# ELEVATION CERTIFICATE

CORRECTION / TRACKING SHEET  
**Marco Island Building Services**  
50 Bald Eagle Drive Marco Island FL 34145 Ph: 239-389-5059

PERMIT# 15-8342 JOB ADDRESS 173 Gulfstream

**CORRECTION REQUIRED/RESPONSE:**  
**Date:** 2016-09-09

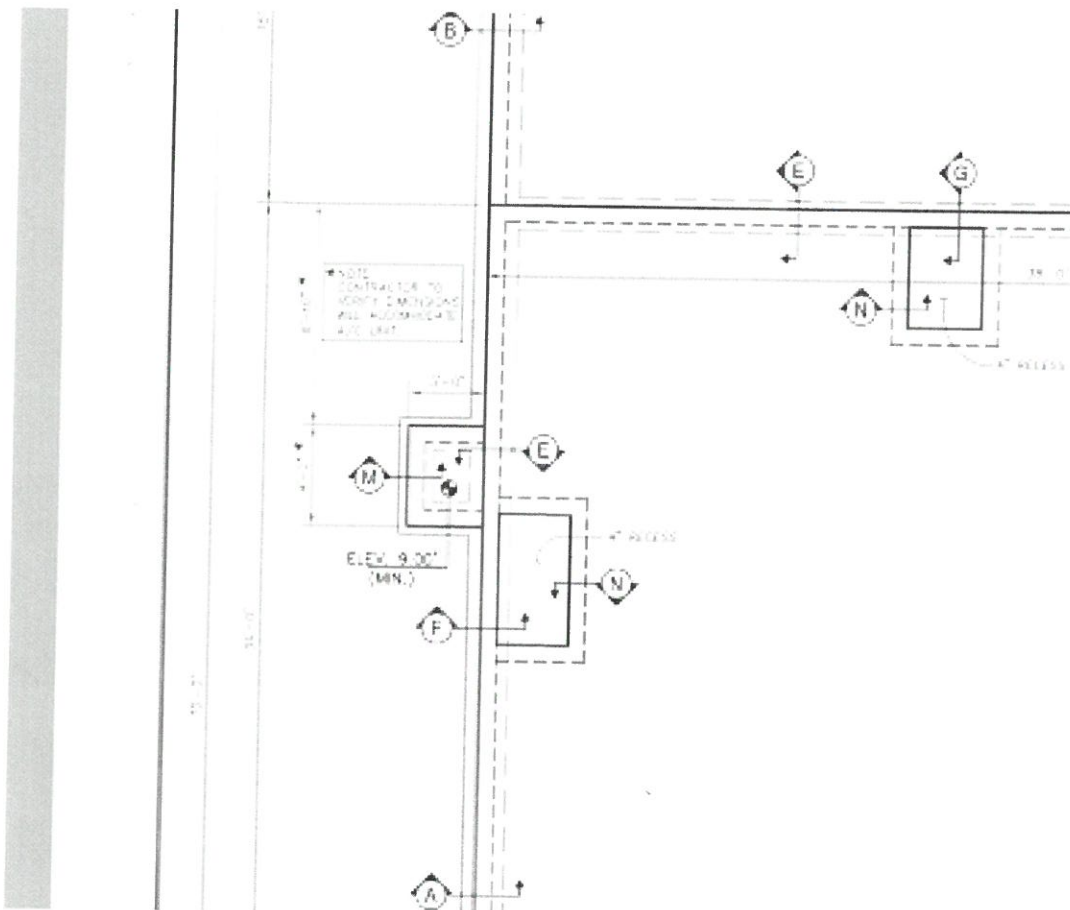
With the additional louvers installed it reduces the actual opening to allow flood waters in; thus the calculation is not accurate on the elevation certificate. Below is a link on how to calculate the opening on non-engineered flood vents.

After review of the final elevation certificate, approved plans and installed hydrostatic flood vents it appears additional louvers were installed over the openings (see pictures below).

*Removed Louvers on  
all 4 openings*
